Project	IEEE 802.16 Broadband Wireless Access Working Group < http://ieee802.org/16 >
Title	Cleanup for security section
Date	2006-01-1105
Submitted	
Source(s)	Changhong Shan Huawei Num 98, Long 91, Road Eshan, Pudong, Shanghai, China 200127 Voice: +86-21-68644808ext23277 Fax: mailto:ritatv@huawei.com
Re:	Section 14.5.5 Security Management, IEEE802.16g-05/008r2
Abstract	In security section of current 802.16g-05/008r2 baseline document, there are some ambiguous or unreasonable description and definition. We do some modification in order to make it clear.
Purpose	The purpose of this contribution is to describe a universal naming schema for NSP List TLV and NSP Count TLV section 14.5.5 defined in 802.16g baseline document and modify some unreasonable primitives or messages.
Notice	This document has been prepared to assist IEEE 802.16. It is offered as a basis for discussion and is not binding on the contributing individual(s) or organization(s). The material in this document is subject to change in form and content after further study. The contributor(s) reserve(s) the right to add, amend or withdraw material contained herein.

[Change section 14.5.5 as follows]

Figure 311 EAP based Authentication Procedure

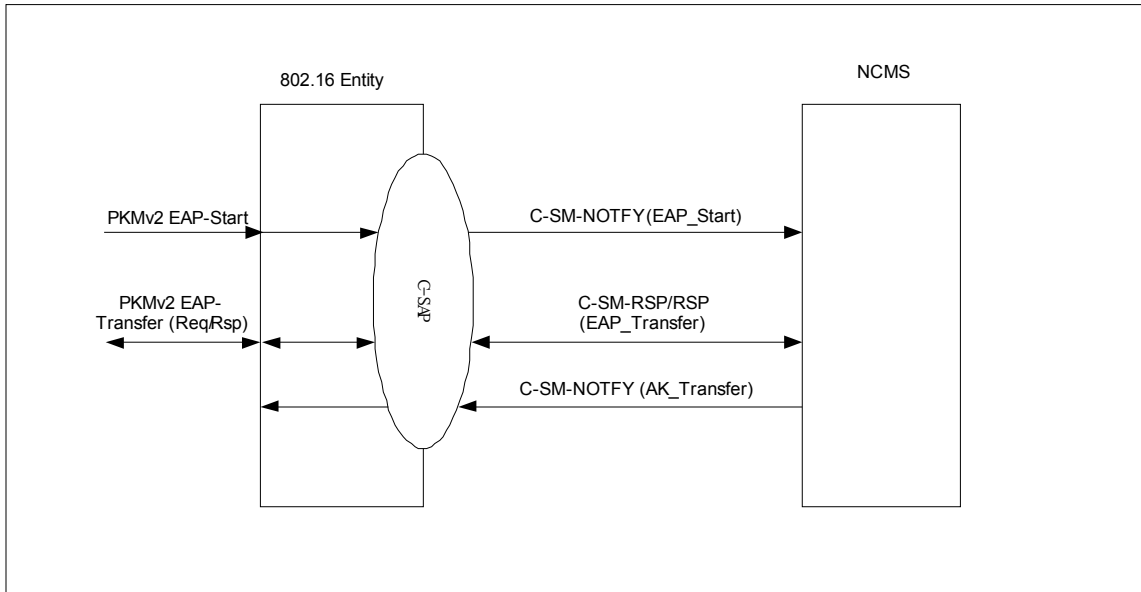
Secondly, we change the C-SM-NOTIFY/EAP_Key into C-SM-NOTIFY/AK_Transfer, for it is not appropriate to transfer MSK to BS from NAS in NCMS. MSK shall be transferred to NAS from Authentication Server (such as AAA Server), then NAS will yield AK and part of its context and send them to BS.

Thirdly, BS shall tell NAS of Authorization Policy Support (Single EAP or EAP after EAP, etc..) which is negotiated in SBC-REQ/RSP procedure. So we add Authorization Policy Support attribute into C-SM-REQ/EAP_Start.

When an MS try to initiate an EAP-based authentication or re-authentication procedure with a BS, it sends a PKMv2 EAP Start message. The BS informs of an NAS (Network Access Server) entity in NCMS as an C-SM-REQ/EAP_Start~~EAP_start_request~~ primitive. If the MS receives EAP-Request/Identity messages, then it sends the EAP-Response/Identity message with MN's identifier to the NAS entity. After the EAP-Response/Identity message, the EAP methods are negotiated between the MS and the AAA server and the EAP messages are exchanged several times. The EAP messages encapsulated are exchanged between the MS and the NAS entity. If the EAP authentication procedure is finished successfully and also yields an MSK (Master Session Key), the BS which does not know EAP protocols receives the MSK and a key lifetime from the EAP client entity as an C-SM-NOTIFY/EAP_Key~~EAP_Key_Notification.indication~~ primitive. It is already shared between the AAA

Figure 312 RSA based Authentication Procedure

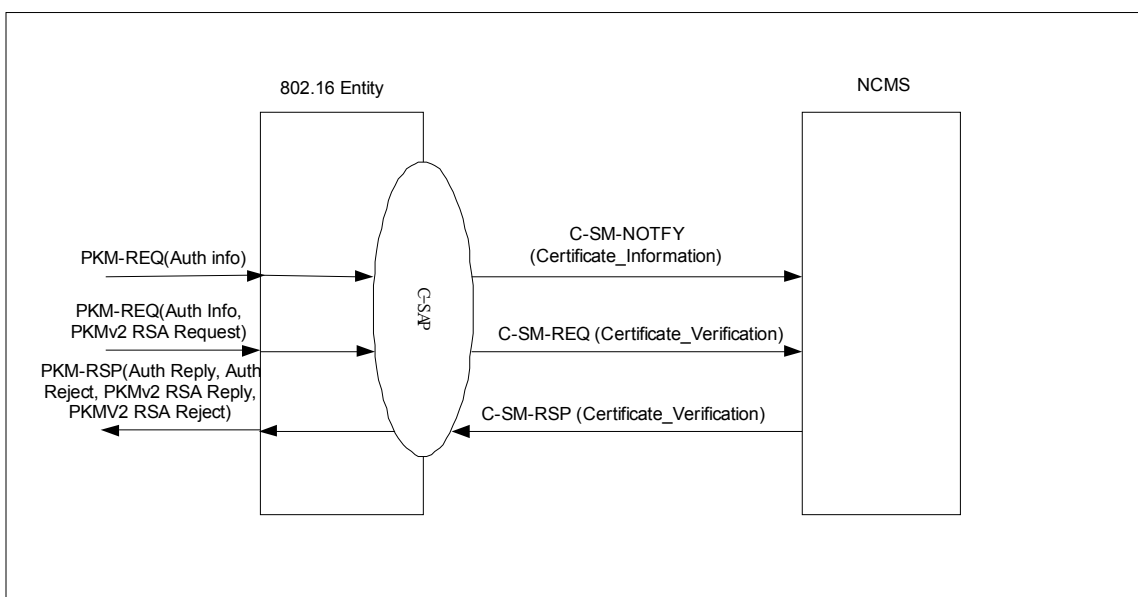
When an MS sends a PKM-REQ message with Auth Request or PKMv2 RSA-Request message type to authenticate the MS, the BS informs of an NCMS entity as a C-SM-REQ/Certificate_Verification~~Certificate_Verification_Request~~ primitive. An NCMS entity
